**City of Portland, Maine – Building or Use Permit Application** 389 Congress Street, 04101, Tel: (207) 874-8703, FAX: 874-8716

Location of Construction: 83 Jeanne Street, Portland, ME 04102		Owner: Ronald & Barbara Hager		Phone: 761 0338		Permit No: 980383	
Owner Address: 83 Jeanne Street		Lessee/Buyer's Name:		Phone:		BusinessName:	
Contractor Name: Jim Libby		Address:		Phone:		Permit Issued: MAR 21 1998 CITY OF PORTLAND	
Past Use: 1-family		Proposed Use: 1-family		COST OF WORK: \$ 6,000		PERMIT FEE: \$ 50.00	
				FIRE DEPT. <input type="checkbox"/> Approved <input type="checkbox"/> Denied		INSPECTION: Use Group: Type:	
Proposed Project Description: replace existing sunroom				Signature:		Signature: <i>[Signature]</i>	
Permit Taken By: Judy Laplante		Date Applied For: 6/16/98		PEDESTRIAN ACTIVITIES DISTRICT (P.A.D.) Action: Approved <input type="checkbox"/> Approved with Conditions: <input type="checkbox"/> Denied <input type="checkbox"/>		Zoning Approval: Special Zone or Reviews: <input type="checkbox"/> Shoreland <input type="checkbox"/> Wetland <input type="checkbox"/> Flood Zone <input type="checkbox"/> Subdivision <input type="checkbox"/> Site Plan maj <input type="checkbox

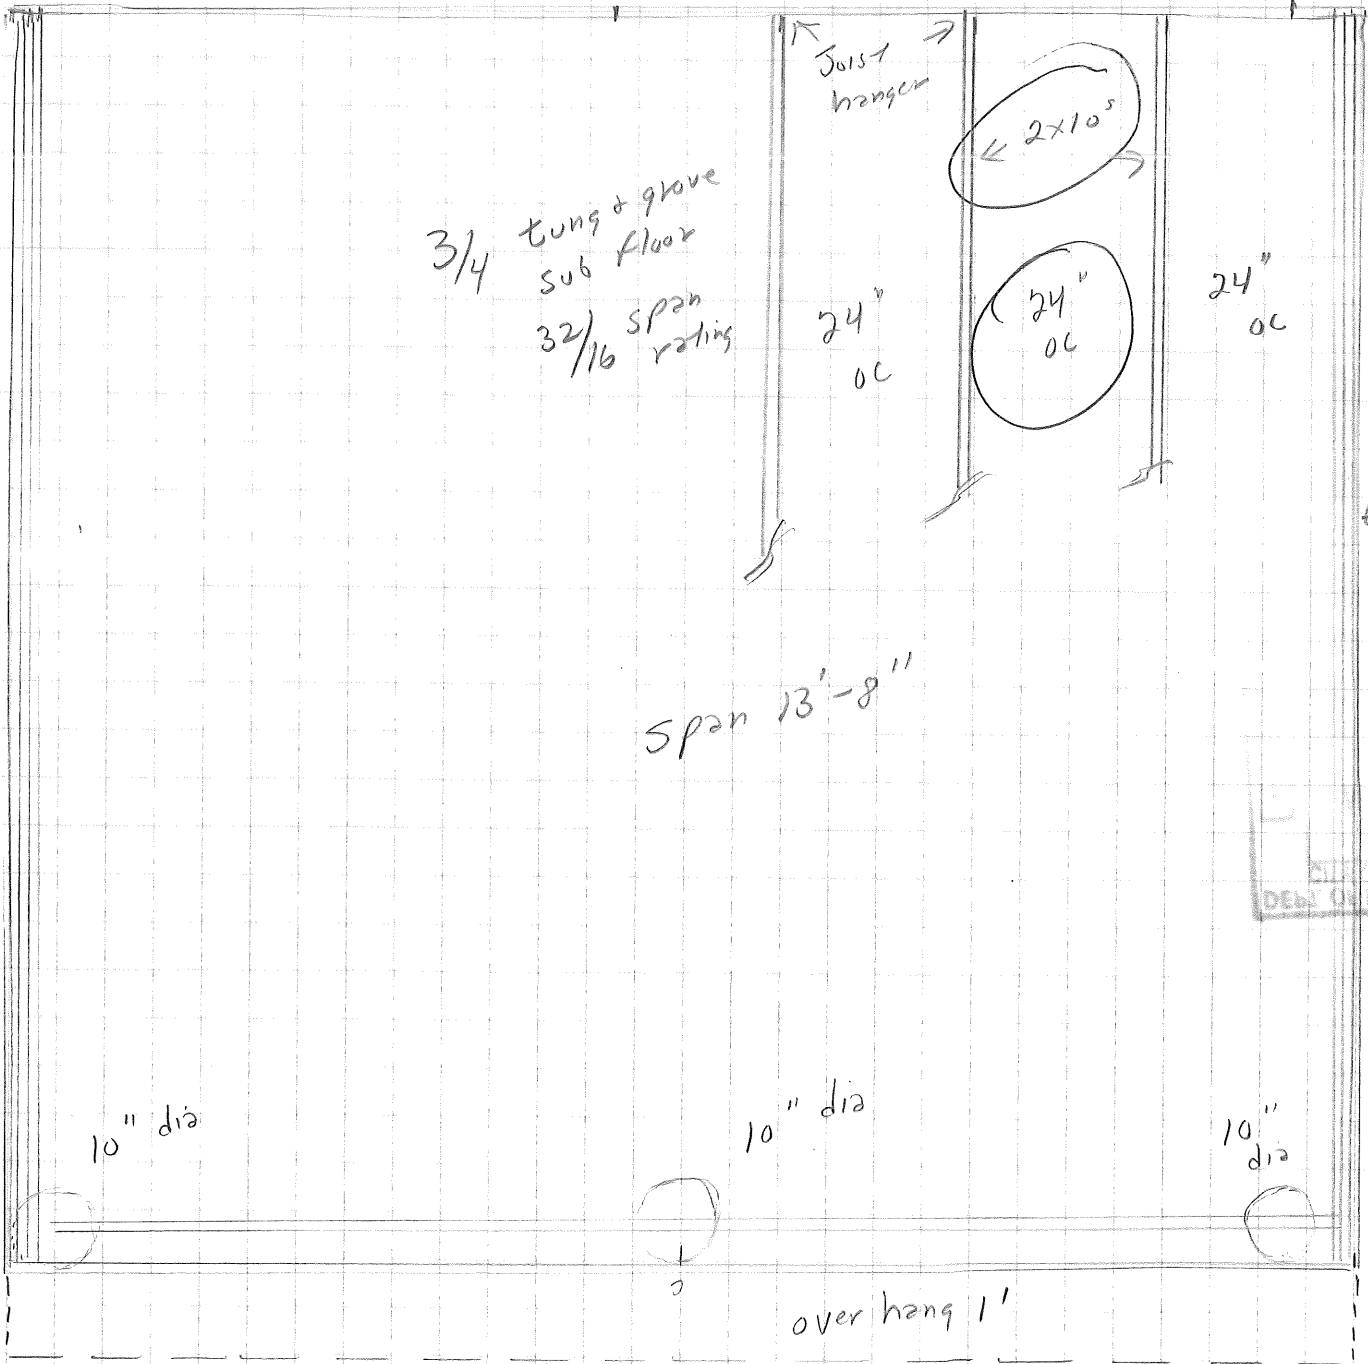
- X 29. Your proposed plan shows 2x10" Floor Joists 24" O.C. spanning 13'8" - That max. span for 2x10" @ 24" O.C. is 12-7" 40 PSF. In PSF. dead load. Therefore, you must redesign the joists system.

- 29) Floor joists now supported with 3 additional piers, center
- 30) Sand tubes connected to fasteners, rest @ 4x48'
- 32) roof rafters = 2x12's @ 24" OC

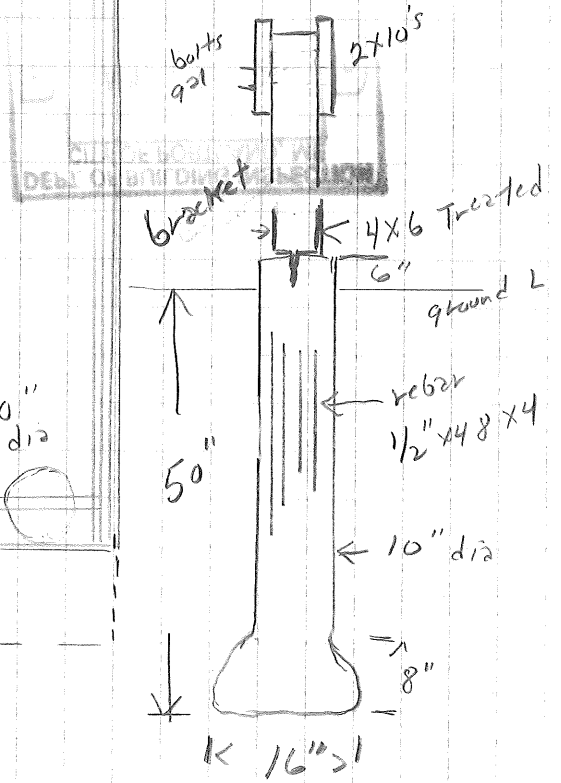
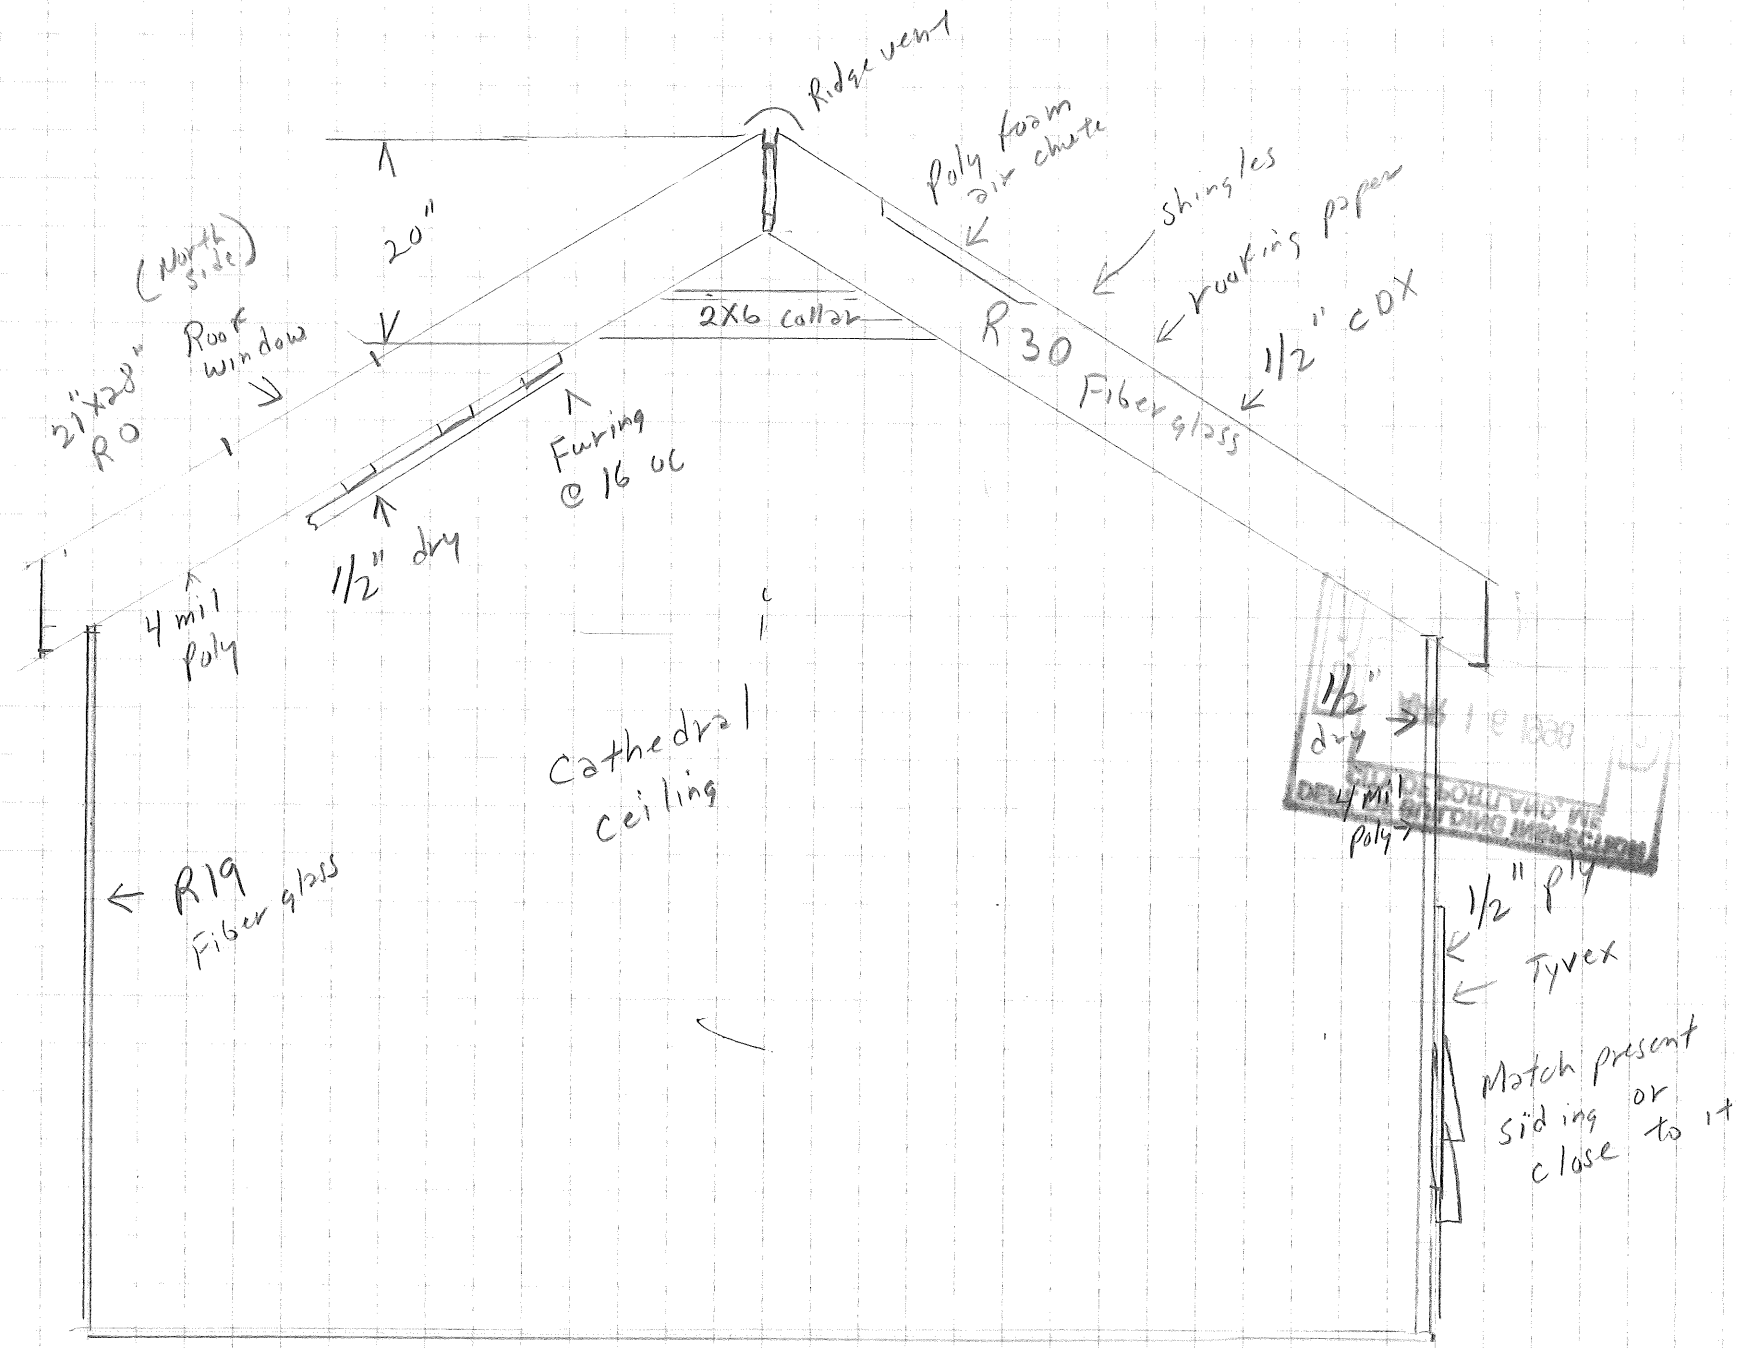
- X 30. The proposed Foundation 10" square Tubes, can only be used if they are placed on Footings with an anchor tie between the footings. Make
- X 32. Your plan does not show size of rafters, please submit this info for review before work begins -
